APPLICATION FOR CERTIFICATION FOR THE ORANGE GROVE POWER PLANT PROJECT BY ORANGE GROVE ENERGY, LLC	DOCKET NO. 08-AFC-4 (AFC filed 06/20/08)

ORANGE GROVE ENERGY LLP'S PREHEARING CONFERENCE STATEMENT

RE: Proposed Modification to Condition of Certification BIO-7

SITE LAYOUT PLAN

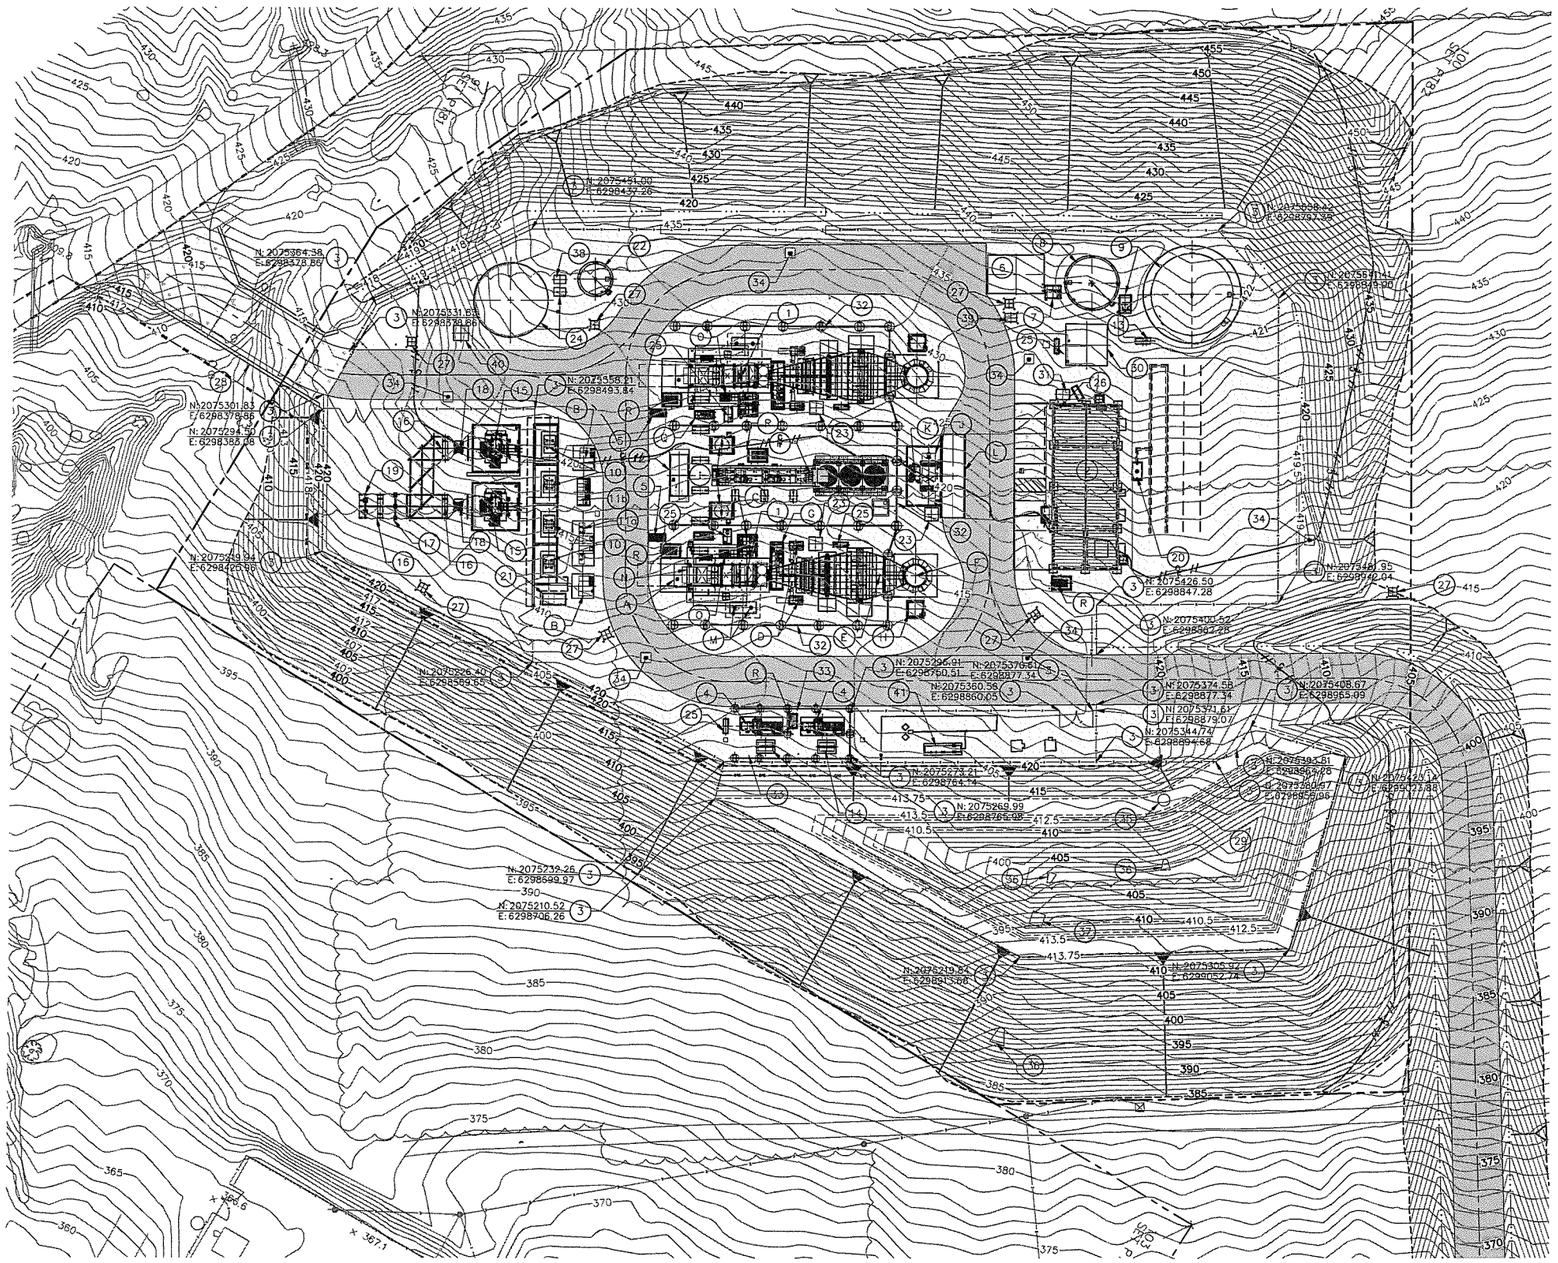
Orange Grove believes it will be able to resolve all hazardous materials, noise and biological resources issues with Staff prior to the Prehearing Conference. Therefore, Orange Grove does not anticipate that any of these areas will require adjudication. Orange Grove has provided additional information to support resolution of the biological resources issue – how far to set the bore pit locations back from the riparian area – in Attachment C.
